# PicoZed FMC Carrier Card

## Revision C

### Errata

Figure 2 – Rework which changes Ethernet Port J11 to Address 0x01

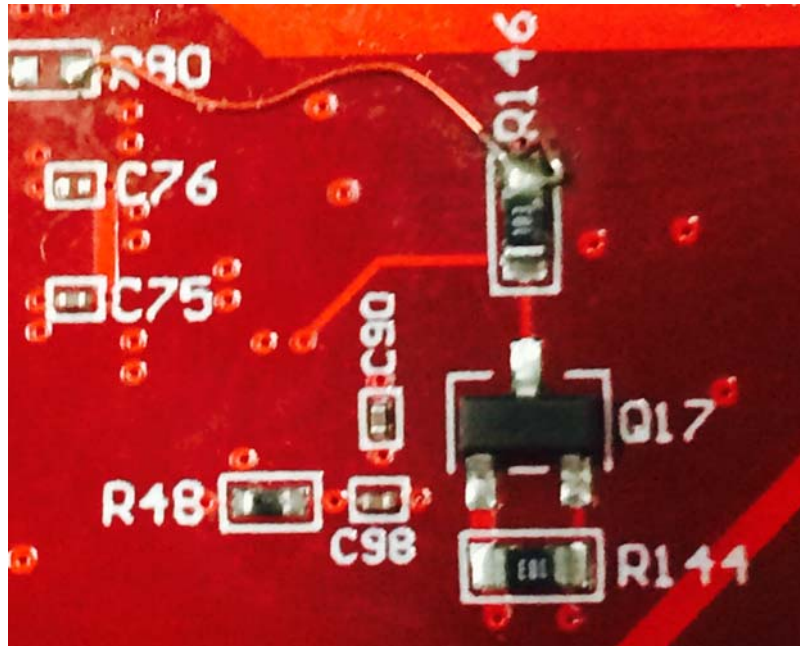
The secondary Marvell 88E1512 PHY on PicoZed FMC Carrier sets the PHY's MDIO address to 0, which is the MDIO broadcast address. Since the Xilinx GMII-to-RGMII shim is also on the MDIO bus, the shim could potentially interfere with communication to the PHY (although the shim does not respond to the broadcast address as of Vivado 2014.4).

Remove R80. Wire the top of R146 to the right pad of R80. This changes the PHYAD[0] from a '0' to a '1'.
